Seismic Walkdown Checklist (SWC) SWEL1-074

ATTACHMENT 9.6

SEISMIC WALKDOWN CHECKLIST FORM

IP2

Seismic Walkdown Checklist (SWC) SWEL1-076

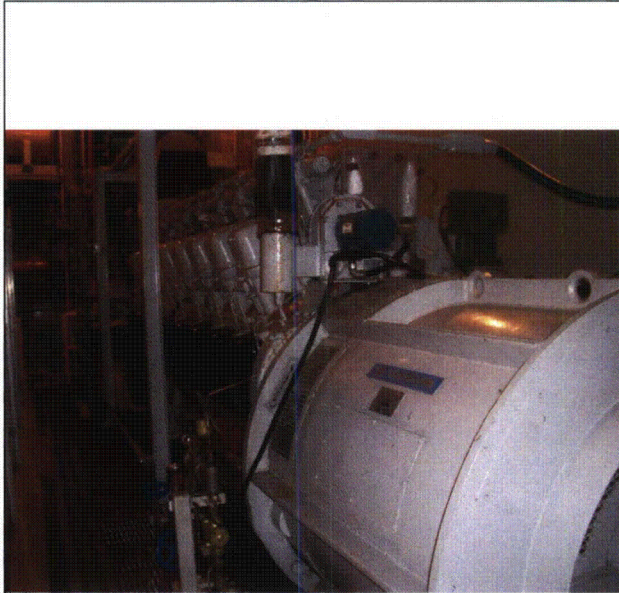
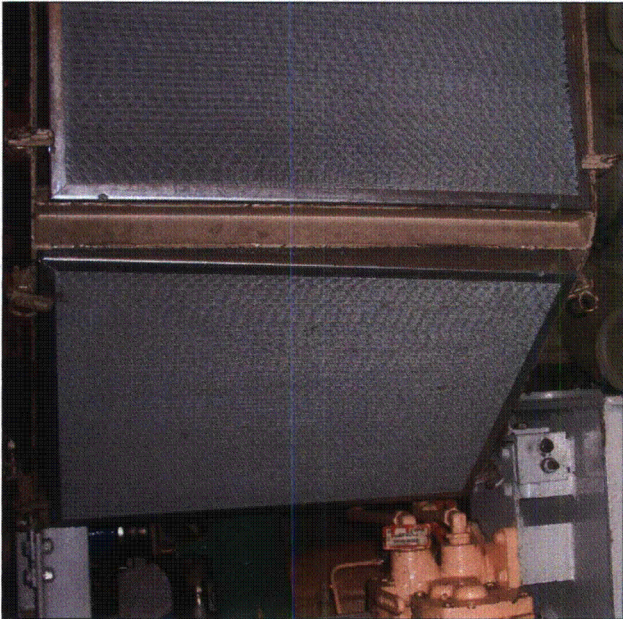
LOWER AIR FILTER NOT FULLY LATCHED.

Note:
LOWER AIR FILTER NOT FULLY LATCHED.

Seismic Walkdown Checklist (SWC) SWEL1-077

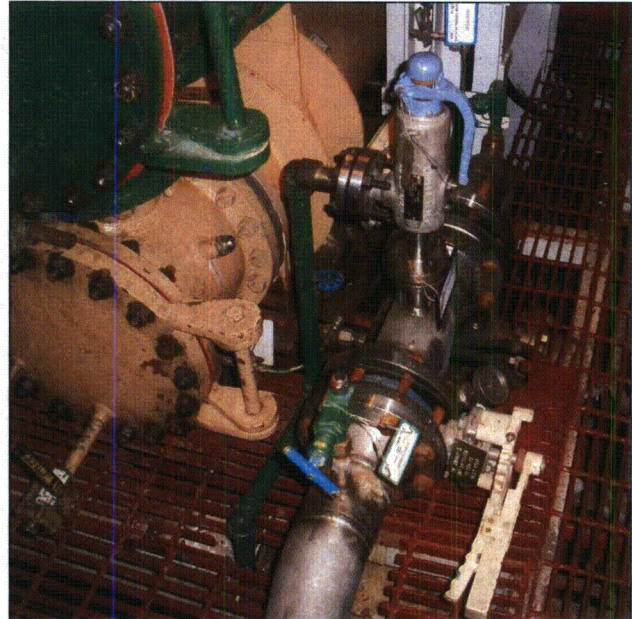
Note: Flange on 22EDG JW & LO Coolers cooling WTR outlet with flush nut and showing minor surface corrosion.

Note: Minor surface corrosion on flange couplings. Possible galvanic corrosion stainless steel pipe and carbon steel bolts.

Seismic Walkdown Checklist (SWC) SWEL1-077

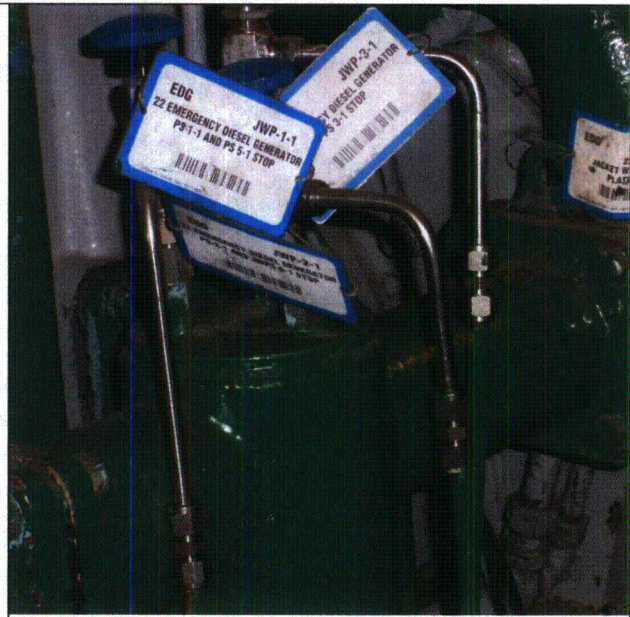
Note: Shows fuse panel for 22 Pre Lube Pump, 22 Lube oil HTR, and 22 Jacket Water HTR that has damaged & missing grout under the eastern (close) posts base plate.

Note: Example of tubing touching a pipe.

Seismic Walkdown Checklist (SWC) SWEL1-077

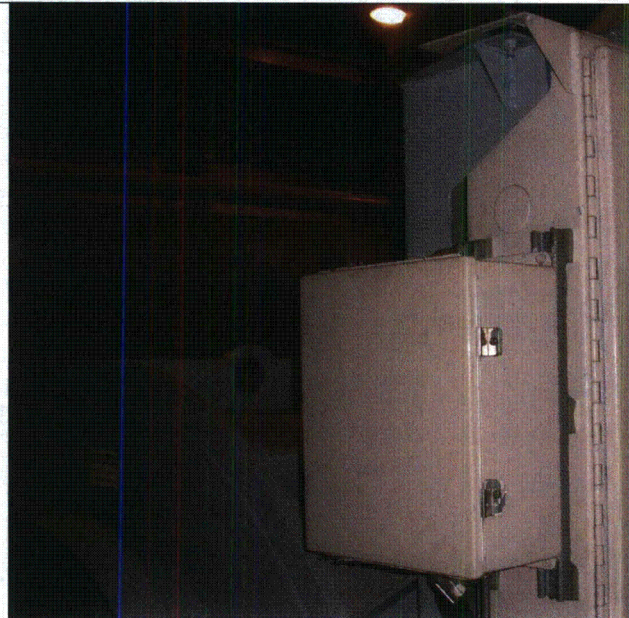
Note: *Example of rubber tubing touching.*

Note: *Latch on 22EDG Gauge board cover panel on north side is not latched.*

Seismic Walkdown Checklist (SWC) SWEL2-005

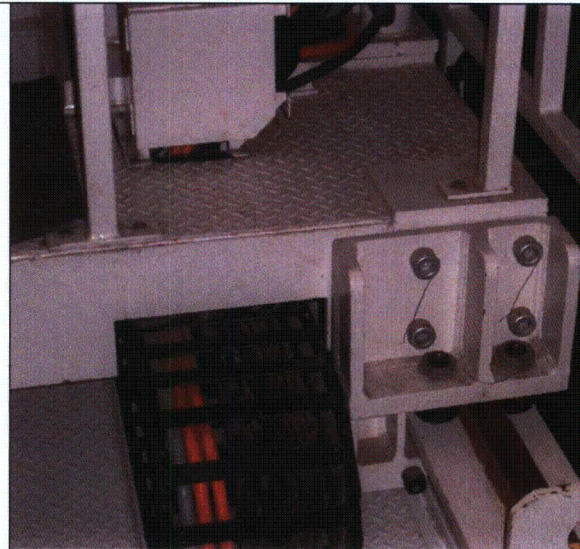
Note: Mast uplift bracket so mast will not topple over into the SFP do to a seismic event.

Note: Mast uplift bracket so mast will not topple over into the SFP do to a seismic event.

Area Walk-By Checklist (AWC) AWC-001

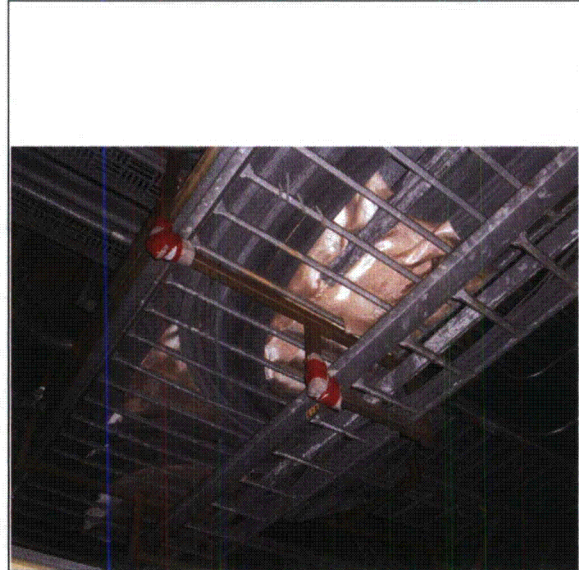
Note: Missing conduit anchor on instrument air SOV-1199.

Note: Taped and paper rapped unistrut connections supporting cable tray.

Area Walk-By Checklist (AWC) AWC-001

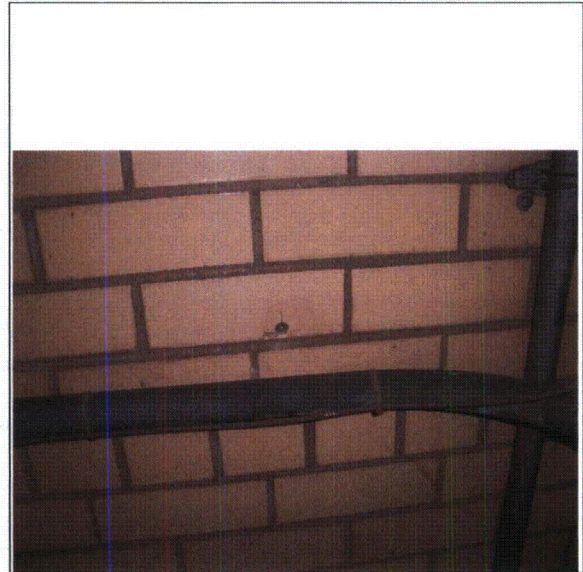
Note: Missing conduit anchor on IACC TC-1106S.
Conduit support spacing judged acceptable.
CR IP2-2012-06495 issued for tracking.

Note: Missing conduit anchor on IACC TC-1106S

Area Walk-By Checklist (AWC) AWC-003

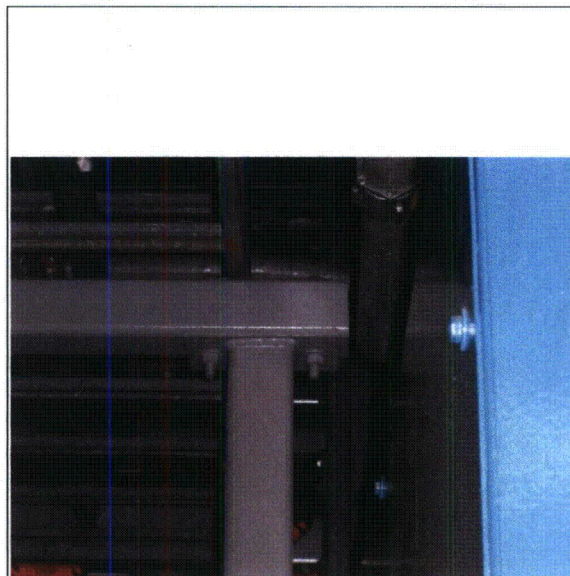
Note: Cabinet hanging on west side of reactor/turbine trip cabinet missing top latch.

Note: Cable tray support over top of 22 MG SET and next to Reactor Trip Breaker cabinet appears to be none seismically designed and appears to have a seismic separation issue with the conduit pictured. Tray support is the tube steel pictured.

Area Walk-By Checklist (AWC) AWC-007

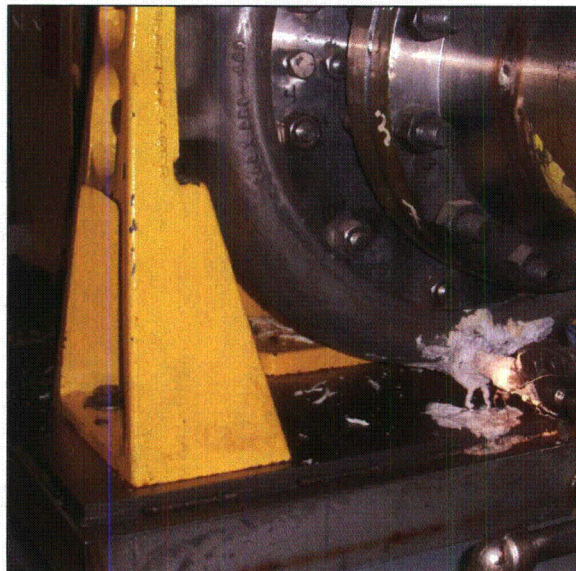
Note: Boric acid leak noted in SWEL2-003 forms.

Note: Boric acid leak noted in SWEL2-003 forms.

Area Walk-By Checklist (AWC) AWC-007

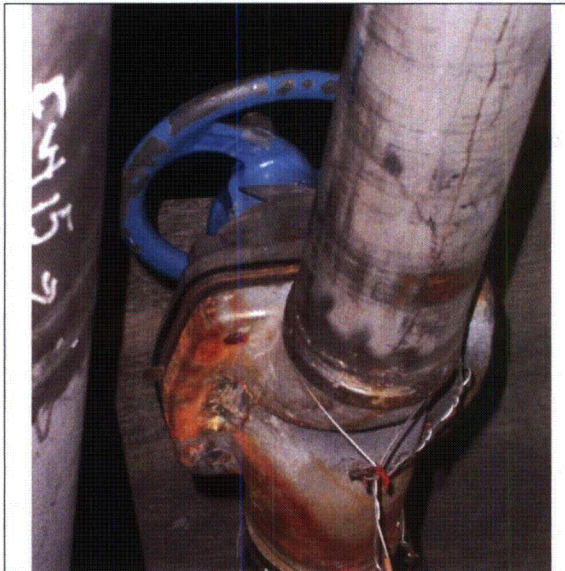
Note: Valve SFP 719A outlet to SFP Demin Stop shows slight surface rust.

Area Walk-By Checklist (AWC) AWC-008

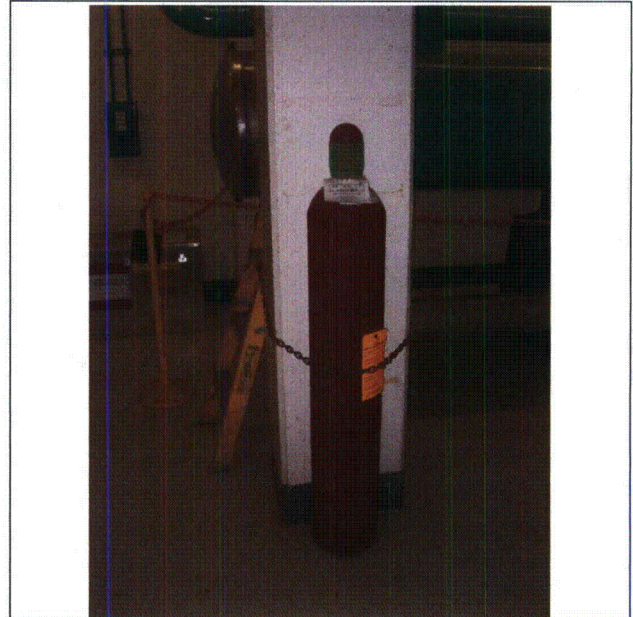
Note: Gas bottle secured to moveable ladder on other side of column. Bottle and ladder can move easily in a seismic event.

Note: Gas bottle secured to moveable ladder on other side of column. Bottle and ladder can move easily in a seismic event.

SWEL Components: SWEL1-036, 037, 047, 060, 076, 077, 078, 081, 084, 087, 096, & 100

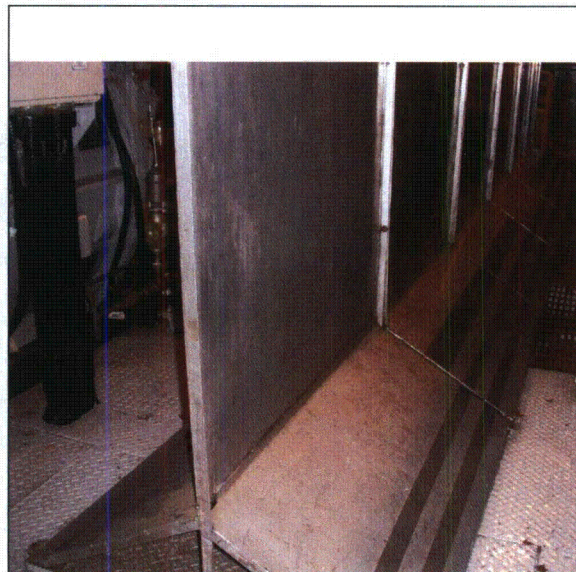
Partitions between EDG's are shown on drawing 207634. These partitions between EDG's have multiple cracked welds (see photos below). These partitions are discussed in CR IP2-2003-03195, and seismically qualified in calculation FCX-00534. These partitions and calculation FCX-00534 require further investigation as cracked welds indicate a problem. CR IP2-2012-06278 issued to track investigation and resolution of the cracked welds. Walk down team judged partitions to be seismically adequate with cracked welds.

Note: Multiple cracked welds on the partitions between EDG's.

Area Walk-By Checklist (AWC) AWC-011

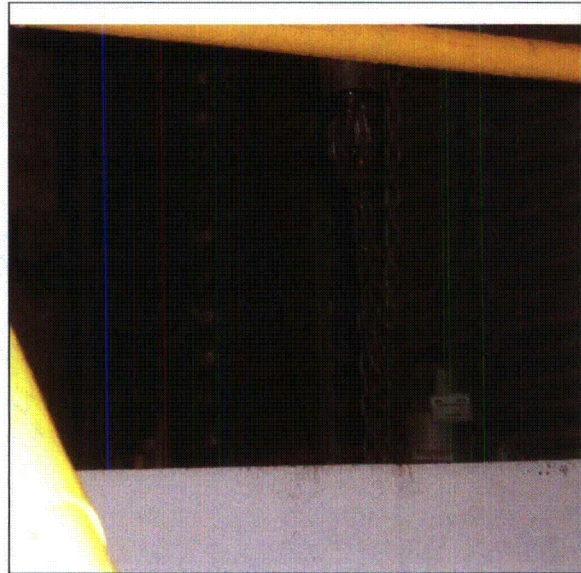
Note: Conduit above door needs support on west side of door. Large conduit above the light shown here. Conduit goes to box TPS-5.

Note: Crane hook is not secured.

Area Walk-By Checklist (AWC) AWC-011

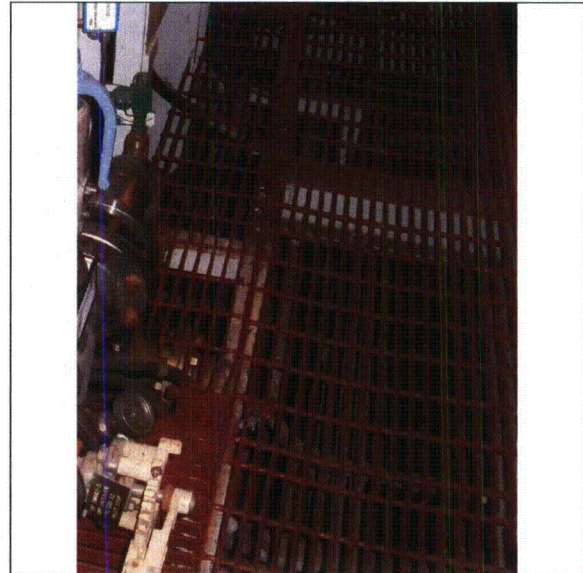
Note: Picture of grating south of EDG 21 & 22 that has baring bars spanning the wrong direction. A noticeable plastic deformation cupping of grating has occurred as cross wires are having to span the opening.

Area Walk-By Checklist (AWC) AWC-012

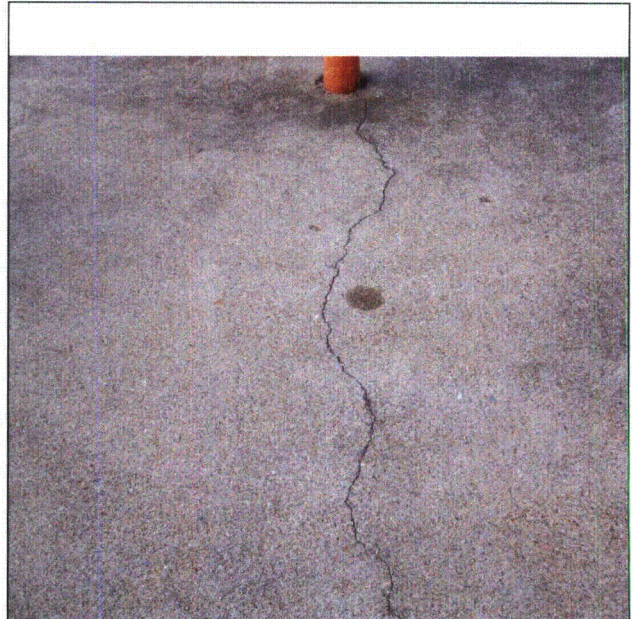
Note: Clear tubing lying on ground should be wire tied inside of the horizontal unistrut.

Note: Example of on grade slab crack.

Area Walk-By Checklist (AWC) AWC-012

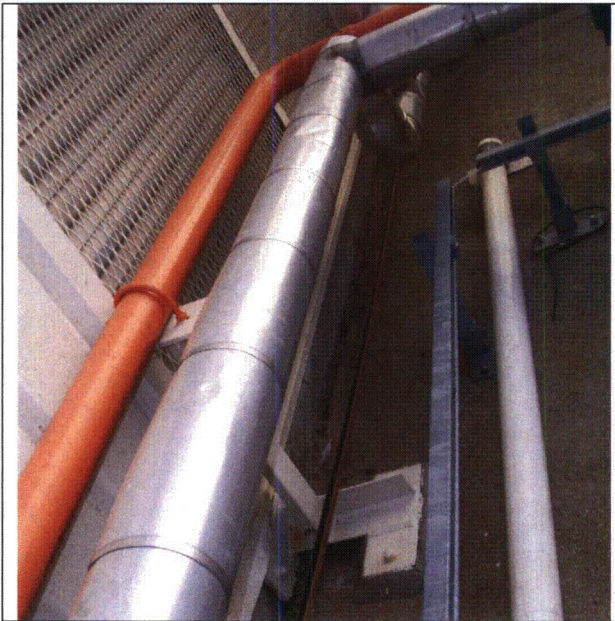
Note: Wood stick laying on ground next to EDG building.
